PD Modification Application: MM 22-1112**Zoning Hearing Master Date:** November 14, 2022**BOCC Land Use Meeting Date:** January 10, 2023**Hillsborough
County Florida**

Development Services Department

**Introduction Summary:**

FIGURE 1

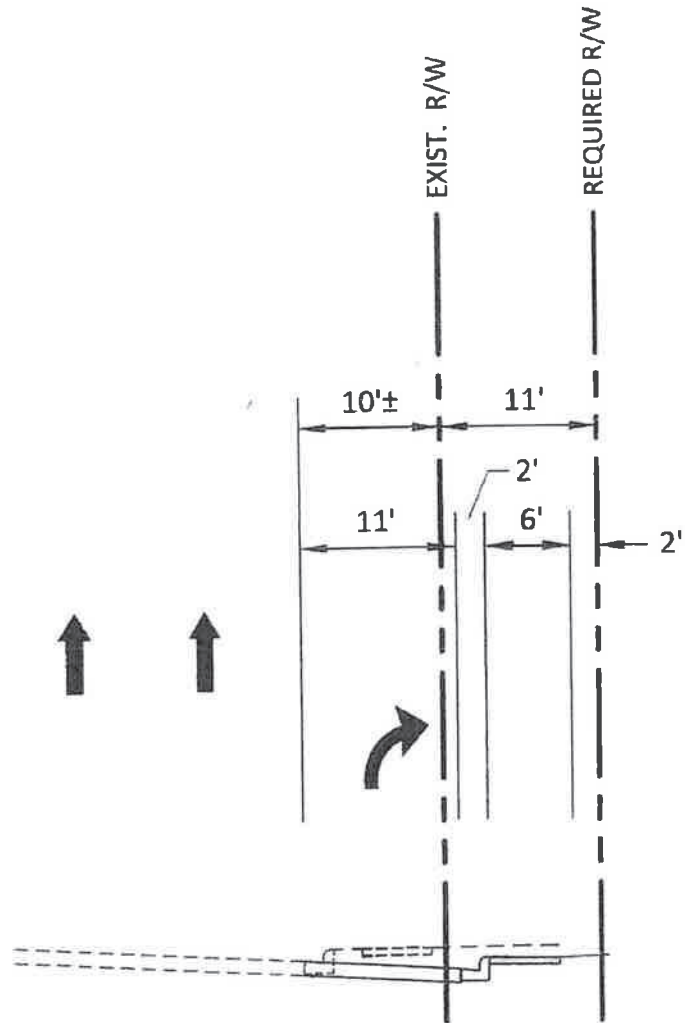
2. There is not sufficient right of way to extend this turn lane. Figure 1 illustrates the existing right of way at the subject access versus what is required for the extension of the right turn lane beyond the 50 feet. As shown, there is approximately 10 feet from the existing edge of pavement of Bloomingdale Avenue to the southern right of way line. In order to provide the right turn lane, approximately 11 feet of additional right of way would be required. The additional 11 feet consists of buffering, landscaping and parking. The developer does not have the ability to eliminate the impacted parking due to existing leases and ownership.
3. There are major utility conflicts with extending the turn lane. Pictures of the utility conflicts are included in the Appendix.

SHEET 5 OF 6	DRAWING PLAN	BD &E	Project Name	Client:
			Winthrop Charter School Winthrop Village Brandon, FL 33509	Landside Investments, LLC. P.O. Box 2638 Brandon, FL 33509 Phone: (813) 681-3480
708 Lithia Pinecrest Road, Suite 101, Brandon, FL 33511 Ph (813) 689-7002 Fax (813) 684-1691			Revision

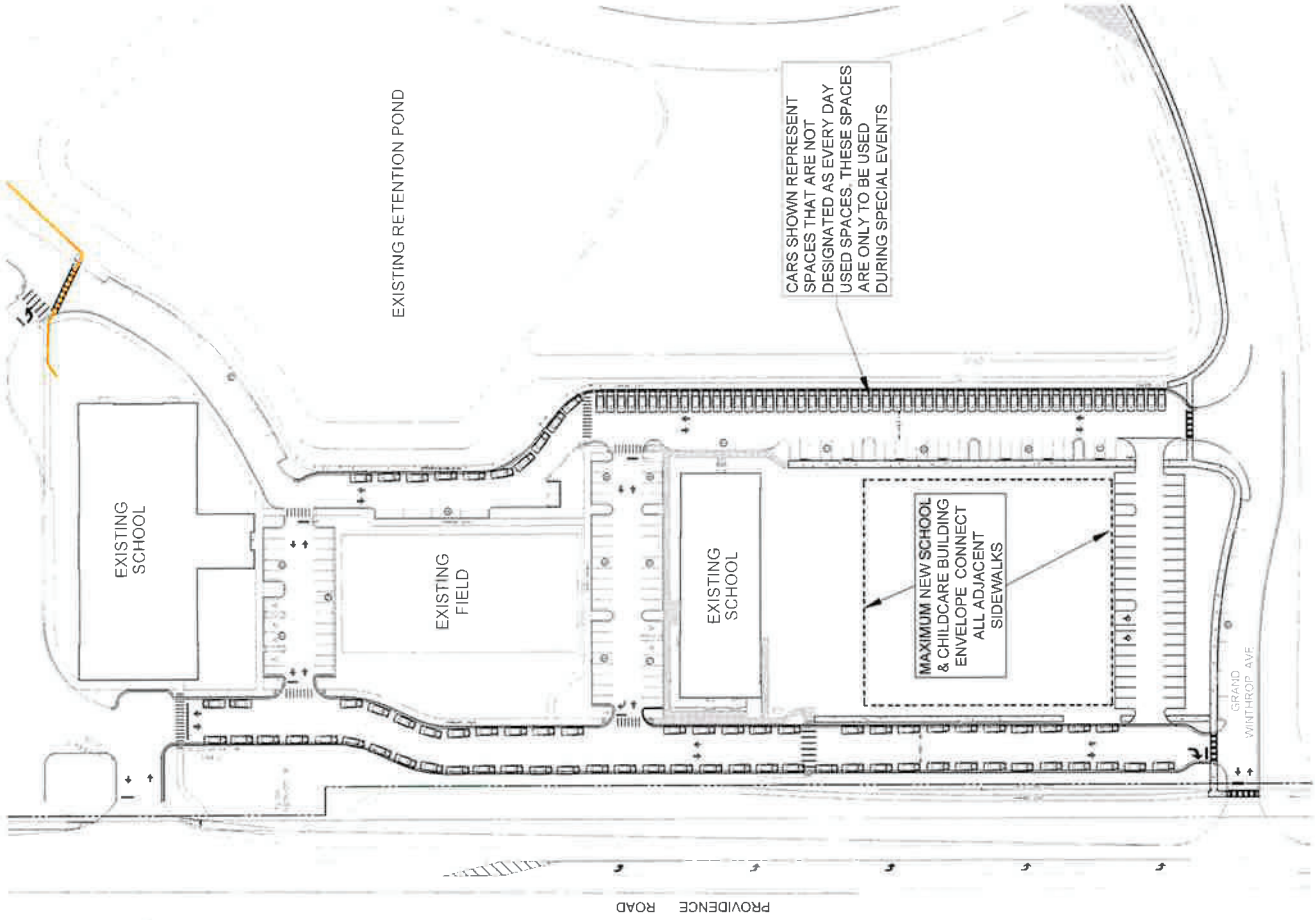
2. The Proposed Site Data table (Sheet 2) to correct the Early Learning square footage from 12,000 to 11,000 sf.
3. Prior to PD site plan certification, the applicant shall revise Sheet 5 of 6 of the PD the site plan to:

- 3.1 Add labels at each applicable access corresponding to the colored placard designations within the circulation notes on the sheet (e.g. the Grand Winthrop Ave. entrance shall be labeled with a prominent note indication "Green Placard Entrance Only");

- 3.2 Modify the circulation notes to correct the placard descriptions/designations, such that all site access points from which students are allowed to enter are accurately described (e.g. no school traffic is permitted to enter via Winthrop Town Center Ave., as such it should not have a designated color or be mentioned).

- 3.3 Add a note indicating that drop-off and pick-up access from any other project entrance is prohibited, and that such restrictions shall be enforced by the charter school operator, master developer and any property owners' associations within the PD.

As shown on Sheet 5 of 6, 1,810 students require 11,087 feet of vehicle queueing and stacking pursuant to Sec. 6.03.13 of the LDC. The proposed queueing plan provides only 7,820 feet of queue. In order to satisfy the remaining 3,267 feet of space, the applicant is proposing to use the special parking area for up to 131 vehicles. Each vehicle would otherwise take up 25 feet of space in the queue. Given this, 131 spaces will accommodate up to 3,275 feet of required queue (which exceeds the 3,267 feet of remaining need). These 131 spaces are currently serving the surrounding retail/office/bank development. In order to confirm that these spaces were available, the applicant provided a parking analysis which examines the number of spaces constructed within the project to date, as well examined the number of spaces required to serve development constructed to date, based on the Winthrop Village TND Code, as referenced in existing zoning condition 11, and as governed by the Winthrop TND Regulating Plan (provided by both zoning staff and the developer).

FIGURE 1
PROPOSED IMPROVEMENTS

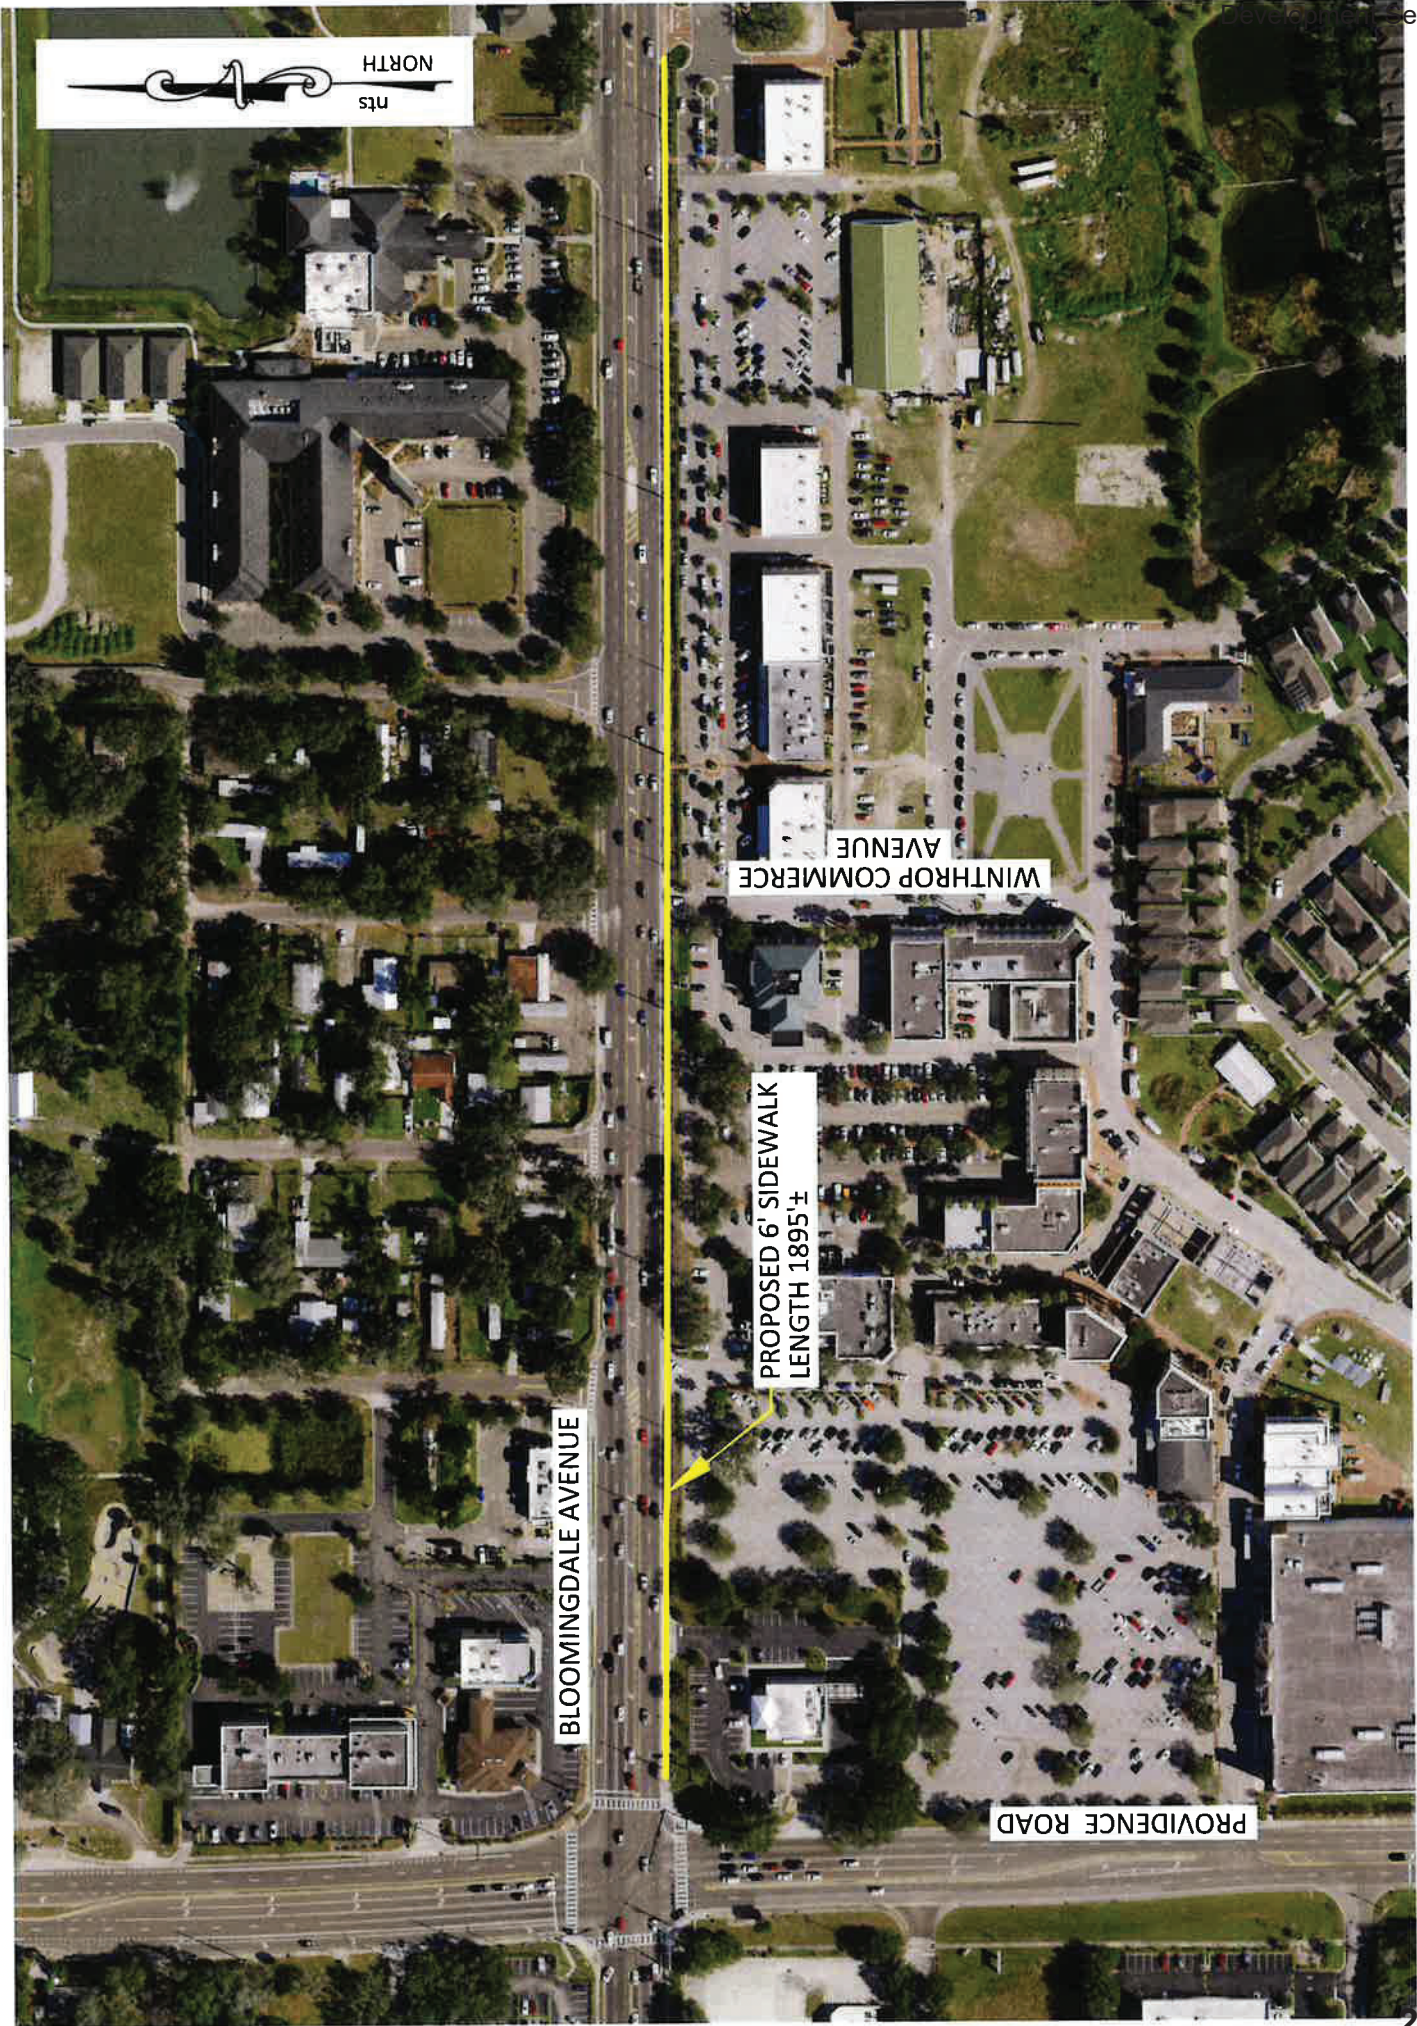
1. The developer will widen the sidewalk on the south side of Bloomingdale Avenue from Providence Road along the property frontage to 6 feet. There may be limited deviations to the 6 feet sidewalk where not feasible due to right of way constraints or utility conflicts as determined by County staff. Figure 1 illustrates the limits of the improvements which is approximately 1,895 feet.

FIGURE 2
PROPOSED IMPROVEMENTS 22-1112

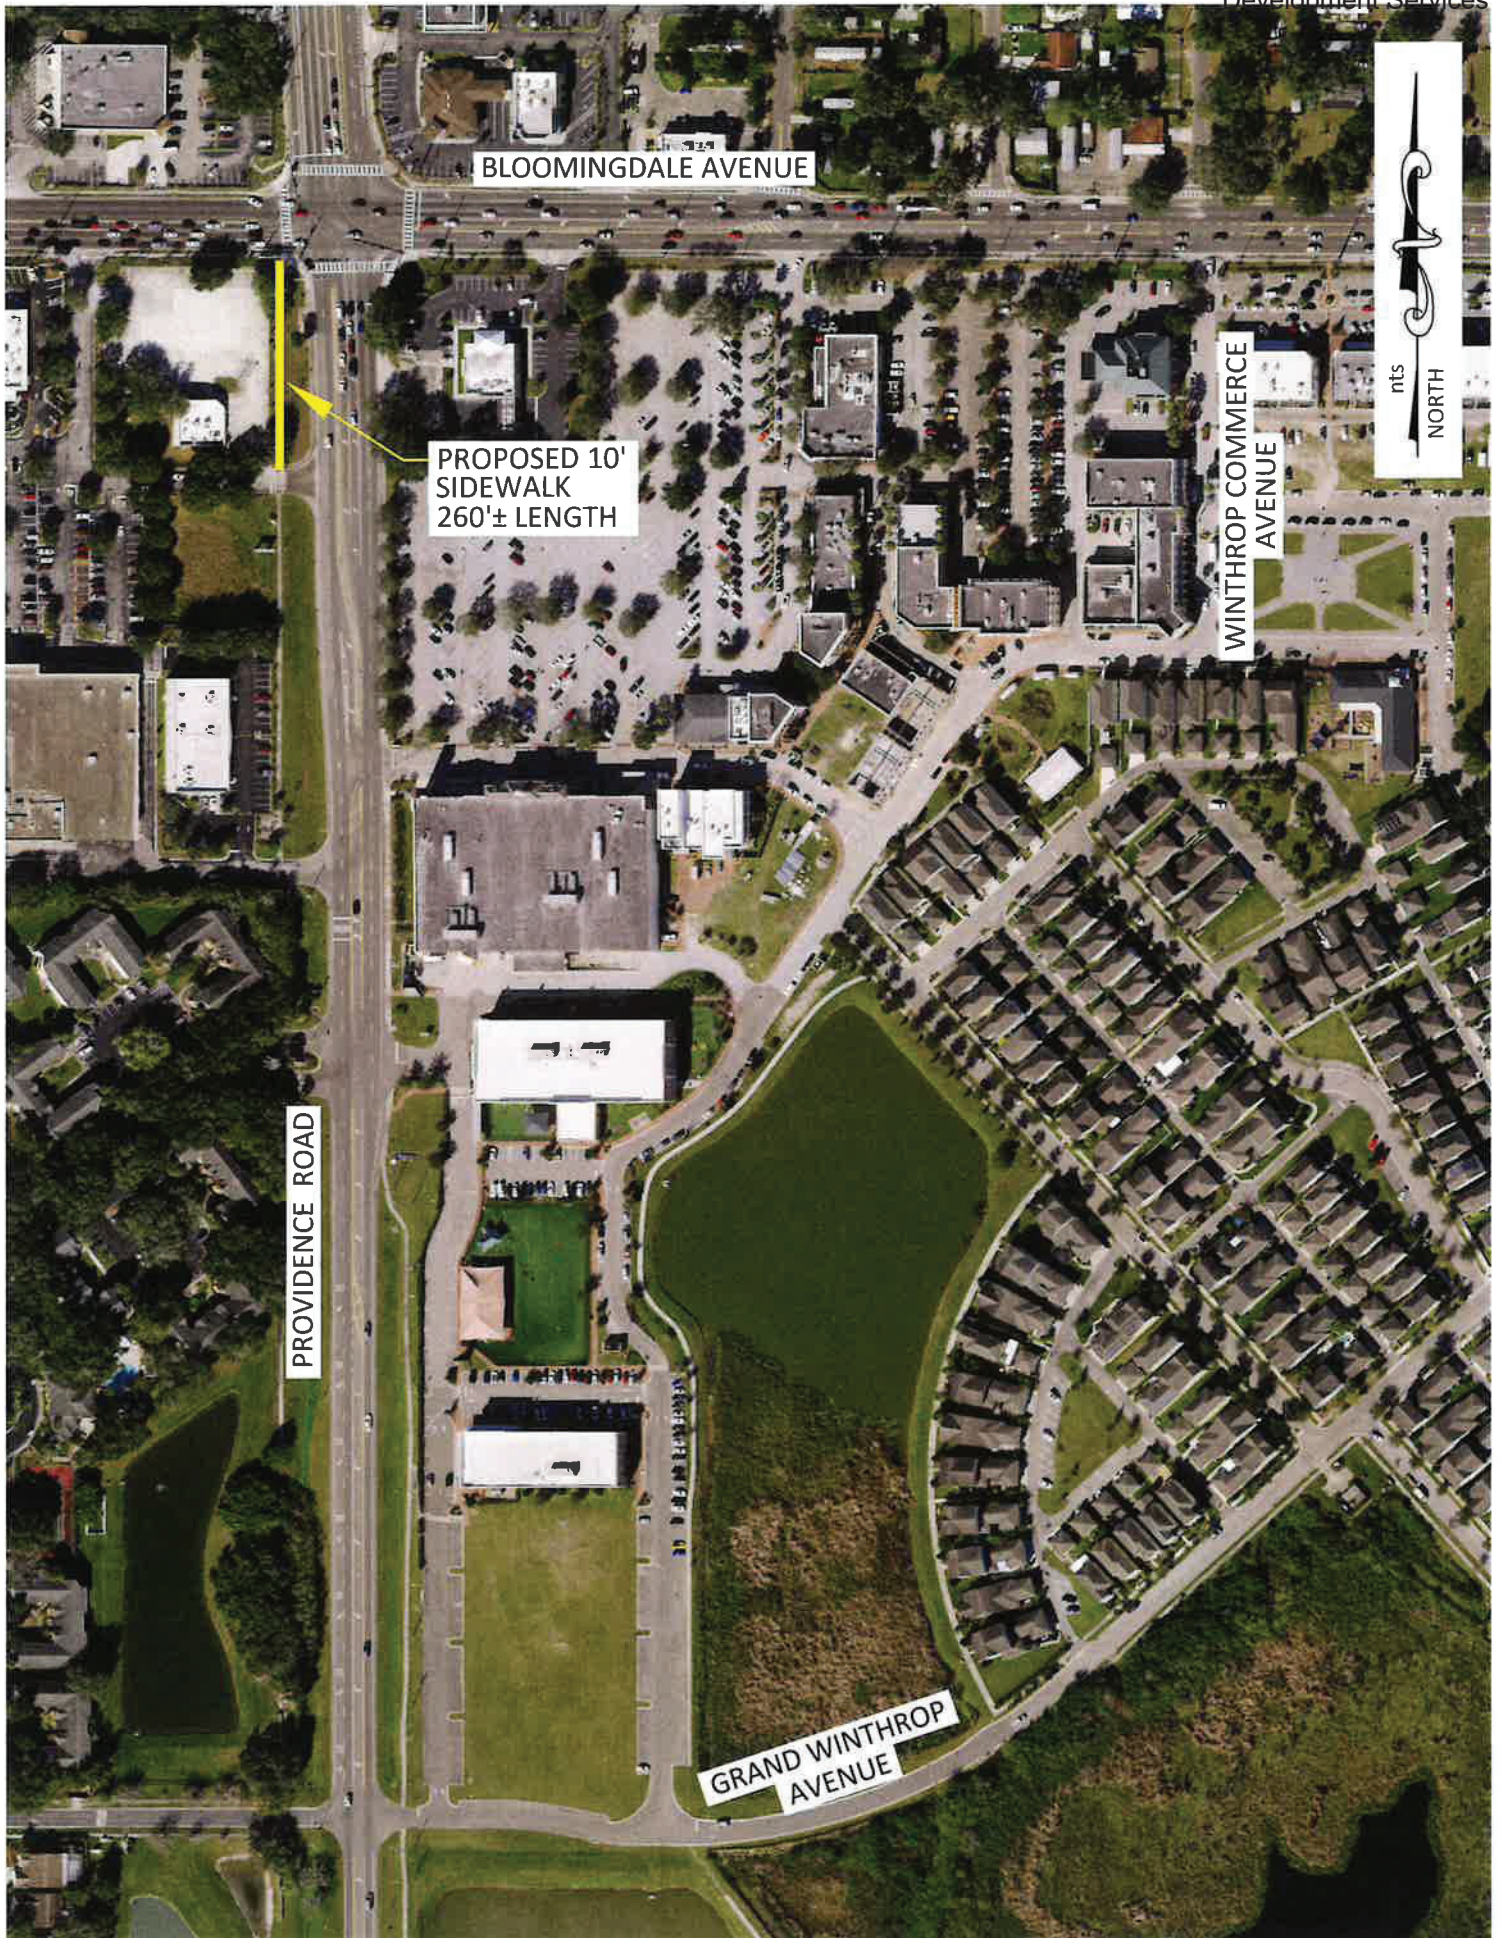
1. The developer proposes to widen the sidewalk on the west side of Providence Road from Bloomingdale Avenue to the retail access to 10 feet for a distance of approximately 260 feet, as shown in Figure 2. This will then connect to the existing bike lanes on the west side of Providence Road.
2. There is not sufficient right of way on the east side of Providence Road to provide the buffered bike lanes or widen the sidewalk.
